Access Compliance Report

Public Rights-of-Way

(Curb Ramps)

Intersection ID: 10018631	Main Street: AGAVA_LN	Cross Street: N/A	Location: SE
ADA ID: E7354F94EC2B	Ramp Type: Perp	Initial Pass/Fail: Fail	Overall Compliance: No
Severity Score: 21.25			
Codes/Mitigation Info/Possible Solution		Field Measurements/Component Compliance

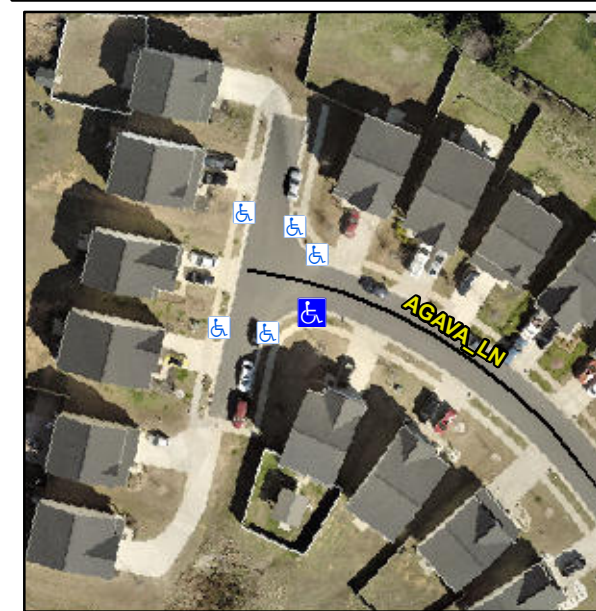
Not Found, R304.5.1, R304.5.3

Compliance	Description	Data	Compliance	Description	Data
N/A	Ramp Length (in)	49.0	Yes	Ramp Slope (%)	7.0
No	Ramp Width (in)	47.5	No	Ramp XSlope (%)	5.1
N/A	Flare Type LT	N/A	N/A	Flare Type RT	N/A
N/A	Flare Slope LT (%)	N/A	N/A	Flare Slope RT (%)	N/A
N/A	Flare Traversable LT?	N/A	N/A	Flare Traversable RT?	N/A
N/A	Landing Length (in)	N/A	N/A	DWS Provided?	N/A
N/A	Landing Width (in)	N/A	N/A	DWS Contrast?	N/A
N/A	Landing Slope (%)	N/A	N/A	DWS Length (in)	N/A
N/A	Landing X Slope (%)	N/A	N/A	DWS Full Width?	N/A
N/A	Landing Curb? (Y/N)	N/A	N/A	DWS Offset (in)	N/A
N/A	Shared Landing?	N/A			
N/A	Gutter Ponding?	N/A	N/A	Gutter Slope (%)	N/A
N/A	Gutter Lip Ht (in)	N/A	N/A	Gutter X Slope (%)	N/A
N/A	Painted X Walk1?	No	N/A	Painted X Walk2?	N/A
	X Walk 1 Direction	To N		X Walk 2 Direction	N/A
N/A	X Walk 1 Width (in)	N/A	N/A	X Walk 2 Width (in)	N/A
	X Walk 1 Slope (%)	0.2		X Walk 2 Slope (%)	N/A
	X Walk 1 X Slope (%)	4.2		X Walk 2 X Slope (%)	N/A

Remove & Replace Entire Ramp.
